Project	IEEE 802.16 Broadband Wireless Access Working Group < http://ieee802.org/16 >	
Title	Clean-up of TTG/RTG and Irregular Subframe in IEEE 802.16mSDD and Amendment Working Document	
Date Submitted	2009-01-07	
Source(s)	Jaeweon Cho, Hokyu Choi, Samsung Electronics Co., Ltd.	+82-31-279-5796 jaeweon.cho@samsung.com
	Sean McBeath Huawei Technologies	smcbeath@huawei.com
	Mo-Han Fong Nortel Networks	mhfong@nortel.com
Re:	IEEE 802.16m-08/052, "Call for Comments and Contributions on Project 802.16m System Description Document (SDD)".	
	<ul style="list-style-type: none"> Target topic: Call for Comment on the SDD draft (IEEE 802.16m-08/003r6; Section 11.3, 11.4, 11.5, 11.6). 	
	IEEE 802.16m-08/053r1, "Call for Comments and Contributions on Project 802.16m Amendment Working Document".	
	<ul style="list-style-type: none"> Target topic: Call for Comment on Amendment Working Document Text (IEEE 802.16m-08/050; Section 15.3.2, 15.3.3, 15.3.5).

Clean-up of TTG/RTG and Irregular Subframe in IEEE 802.16m SDD and Amendment Working Document

Figure 25 Frame Structure with type-1 and type-3 subframes in TDD duplex mode (CP=1/8T_u)

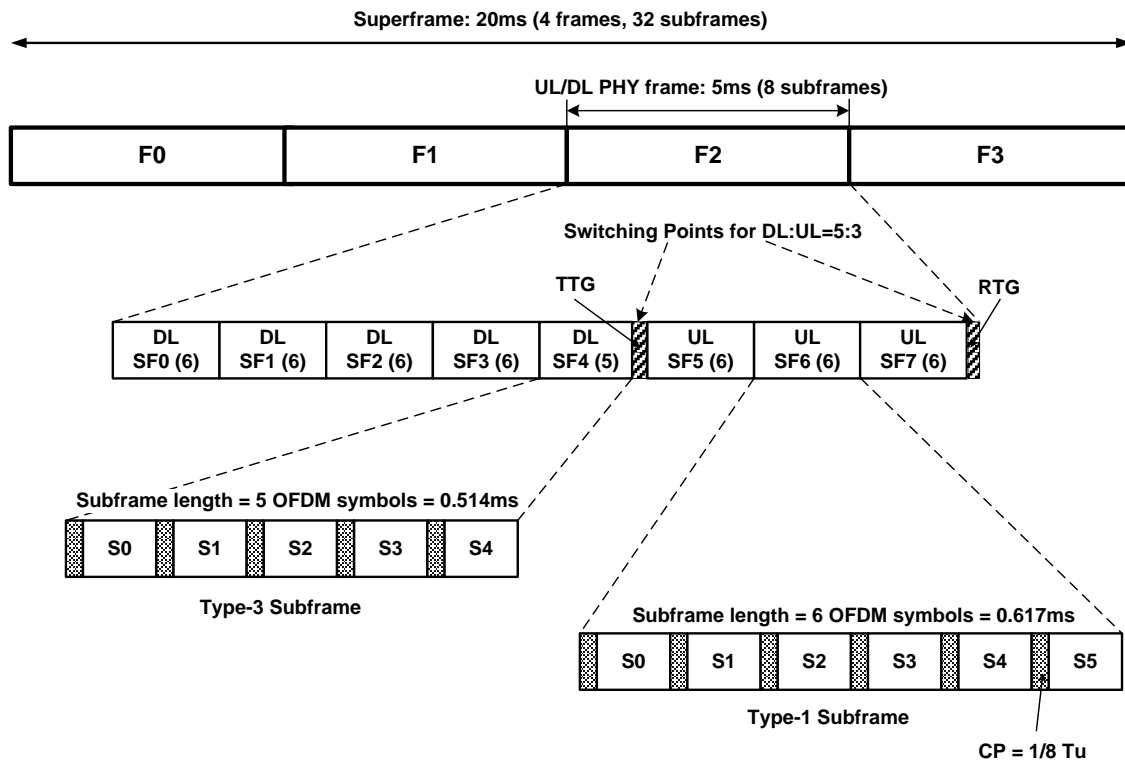
Figure 25 illustrates an example TDD frame structure with DL to UL ratio of 5:3. Assuming OFDMA symbol duration of $102.857\mu\text{s}$ and a CP length of $1/8 T_u$, the lengths of type-1 subframe and type-3 subframe are 0.617 ms and 0.514 ms , respectively. In Figure 25, the last DL subframe, i.e., DL SF4, is a type-3 short subframe whose last OFDMA symbol is an idle symbol to accommodate the gap required to switch from DL to UL.

[Remedy 4: Replace Figure 25 in page 62 with the following Figure]

Figure 27 TDD and FDD Frame Structure with CP of $1/16 T_u$ (DL to UL ratio of 5:3)

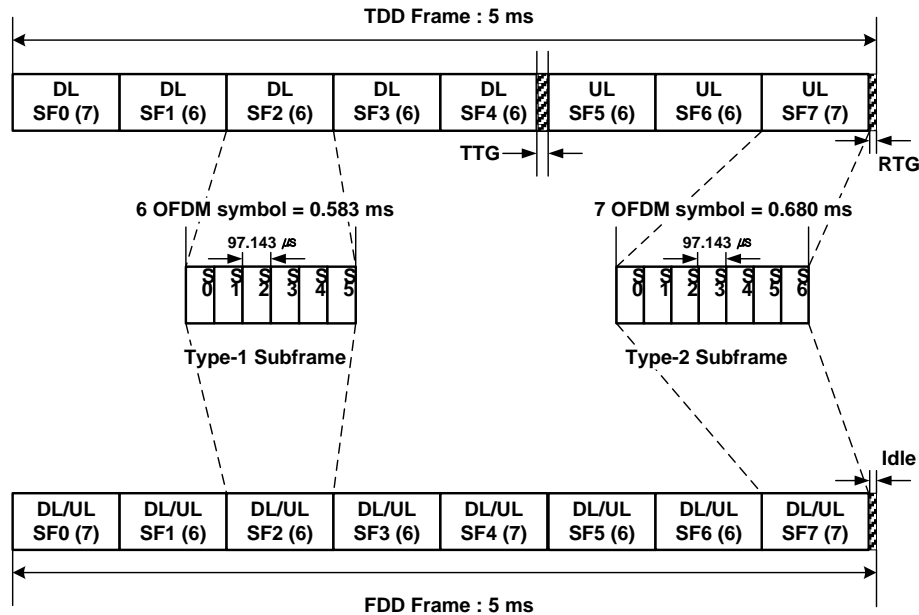
For nominal channel bandwidths of 5, 10, and 20 MHz, an IEEE 802.16m frame for a CP of $1/16 T_u$ shall have five type-1 subframes and three type-2 subframes for FDD, and six type-1 subframes and two type-2 subframes for TDD.

[Remedy 6: Replace Figure 27 in page 63 with the following Figure]

Figure 391 Frame Structure with type-1 and type-3 subframes in TDD duplex mode

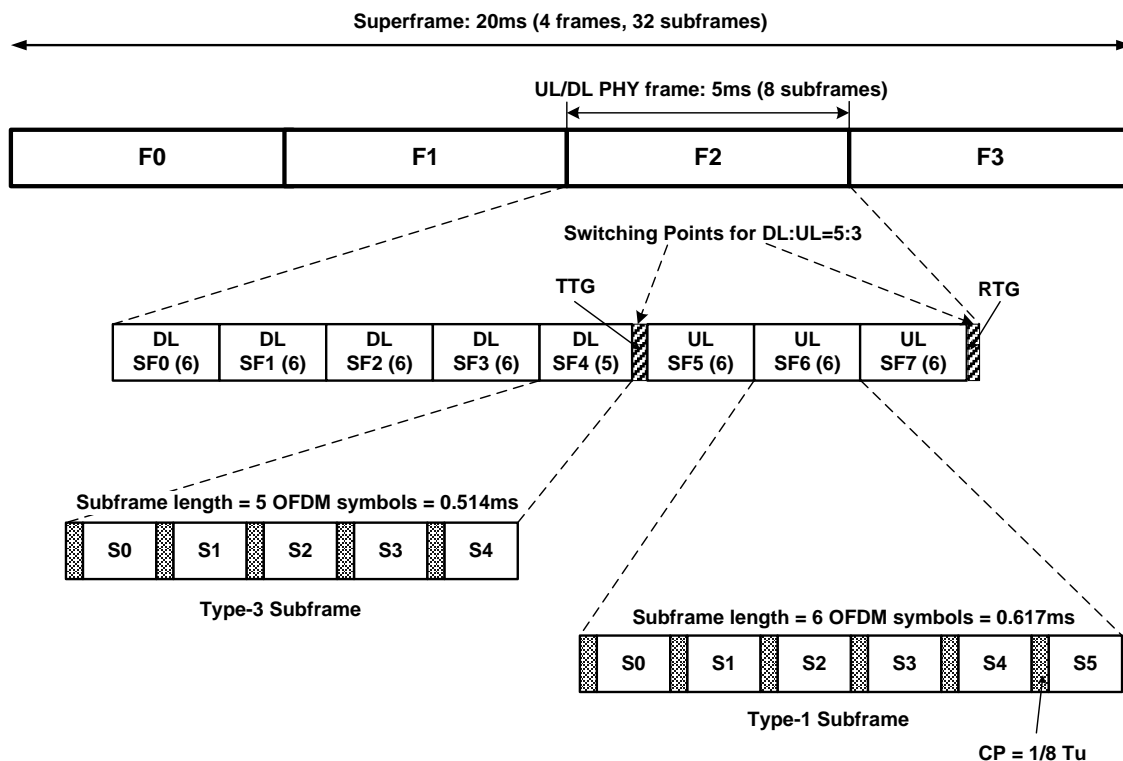
Figure 391 illustrates an example TDD frame structure with D:U = 5:3, which is applicable to the nominal channel bandwidths of 5, 10, and 20 MHz with $G = 1/8$. In Figure 391 the last DL subframe, i.e. DL SF4, is a type-3 subframe and the other subframes are type-1 subframes.

[Remedy 4: Replace Figure 391 in page 17 with the following Figure]

Figure 392 TDD and FDD Frame Structure with CP of 1/16 T_b (DL to UL ratio of 5:3)

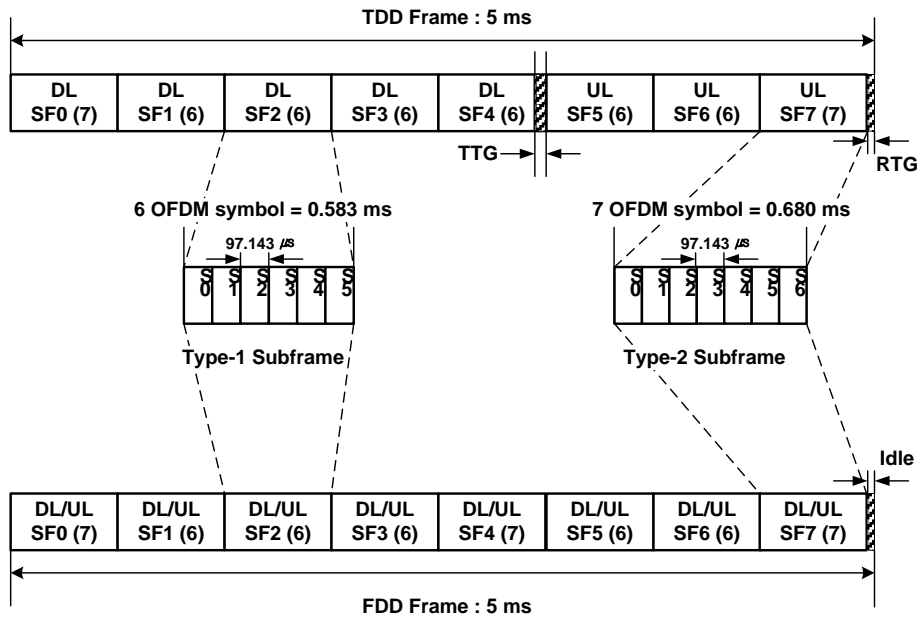
For channel bandwidths of 5, 10, and 20 MHz, a FDD frame shall have five type-1 subframes and three type-2 subframes, and a TDD frame shall have six type-1 subframes and two type-2 subframes.

In the TDD frame, the first and last subframes within each frame shall be type-2 subframes. ~~The last OFDMA symbol in a type-2 subframe preceding a DL to UL switching point shall be an idle symbol, which is used to accommodate the gap required to switch from DL to UL.~~

[Remedy 6: Replace Figure 392 in page 18 with the following Figure]
